## **FULTON ROAD BAPTIST CHURCH SUBDIVISION,** **RESUBDIVISION OF LOT 2**

APPLICATION NUMBER 9 DATE November 2, 2017  
APPLICANT Fulton Road Baptist Church Subdivision, Resubdivision of Lot 2  
REQUEST Subdivision

# DETAIL SITE PLAN

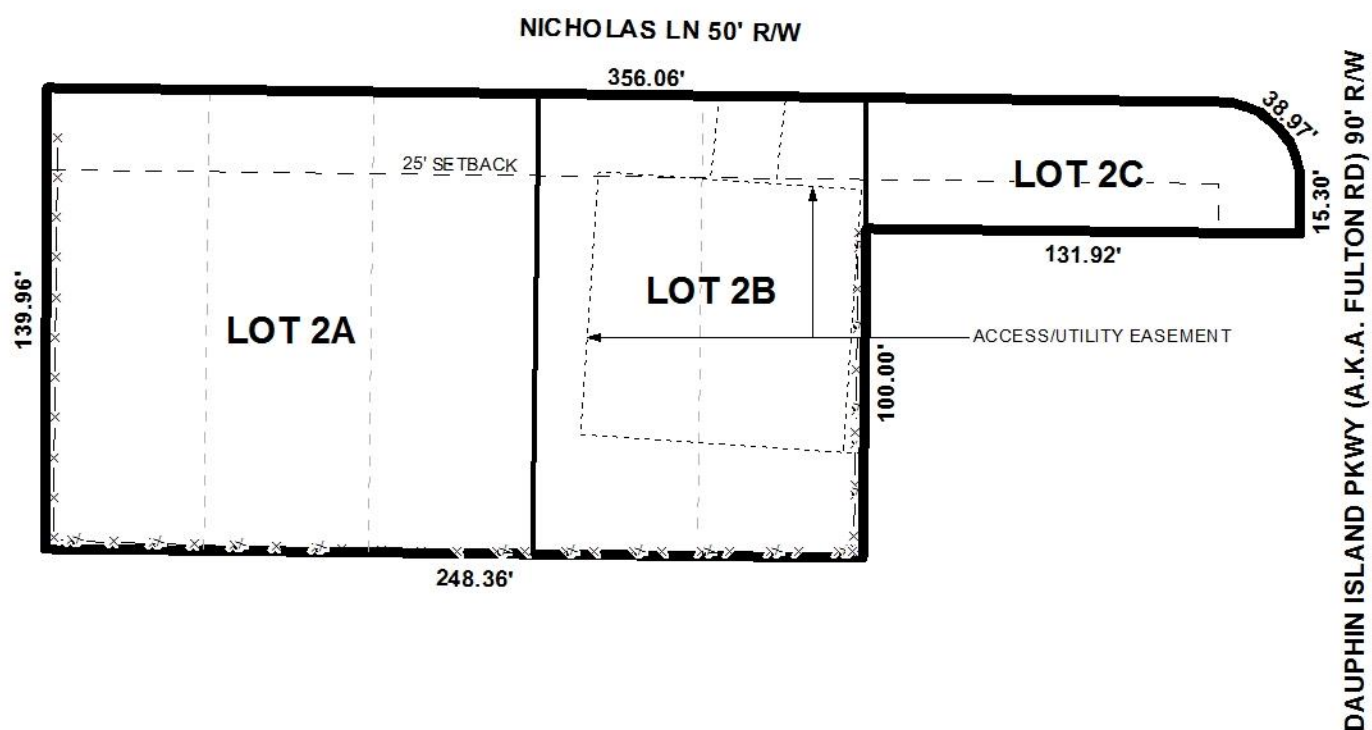
Traffic Engineering Comments: Dauphin Island Parkway (Alabama Highway 163) is an ALDOT maintained roadway. Each lot is limited to one curb cut, with size, location and design to be approved by Traffic Engineering and conform to AASHTO standards. Lot 2C is denied access to Dauphin Island Parkway.

The plat illustrates the proposed 3-lot, 0.9± acre subdivision located at the Southwest corner of Nicholas Lane and Dauphin Island Parkway, in Council District 3. The applicant states the site is served by public water and sanitary sewer.

As proposed, Lots 2A and 2B meet the minimum width and area requirements of Section V.D.2. of the Subdivision Regulations. However, Lot 2C would only be 40' wide and would only contain 5,149 square feet. As this lot was originally Lot 3, Plat No.2, Nicholas Subdivision, Brickyard Tract, and was 50' wide and contained approximately 6,600 square feet, it became a legal nonconforming lot at the time of the adoption of the Subdivision Regulations in 1952. However, its size was further reduced with the frontage dedication required of Fulton Road Baptist Church Subdivision in 2004, but it was incorporated into the much larger Lot 2 of that subdivision. It is now proposed to once again become an individual lot but of even smaller size. As it would be reduced below its original nonconforming size, it cannot be allowed. Therefore, the over-all three-lot subdivision cannot be approved as presented.

**RECOMMENDATION** Based on the preceding, this application is recommended for holdover to the meeting of December 7<sup>th</sup> to allow the applicant to meet with staff to discuss alternatives to the proposed plat.
